**Re: Request for Information
Development Application No: DA2025/0200 for Alterations and additions to a
dwelling house at 14 Kristine Place MONA VALE.**

Reference is made to your letter dated 2 April 2025, requesting further information to undertake a full assessment of the application. As a result of the letter, the following documents have been prepared as additional information or revised to assist the final determination:

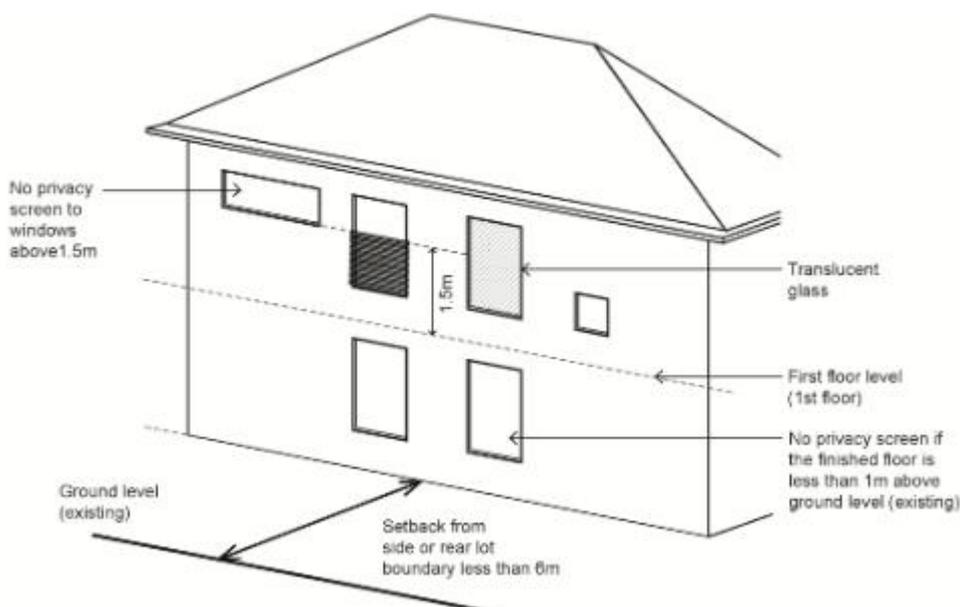
2. Visual Privacy

The proposed deck and DO3 have been removed and included within the first-floor footprint as GFA. The proposed new window W09 is located 12.7m from the side western boundary and will have no adverse impact to that adjoining neighbour. In regards to the other windows mentioned in the RFI, with respect, it is our opinion that the requirement of a 1.7m sill window is an outdated control, noting the allowances in other areas and within the Code SEPP for CDC applications, noting Clause 3.15 on the following page:

As above, the State provisions hold that a 1.5m sill height is sufficient for privacy measures. Noting that the rooms are “low use” rooms as bedrooms and a bathroom window (which is already proposed with frosted glazing), it is our opinion that it is unreasonable to enforce 1.7m, particularly noting that we could apply a CDC application at a later date to achieve the 1.5m sill height.

On the basis that the western balcony/deck has been deleted, the visual privacy concerns are now acceptable for a residential dwelling.
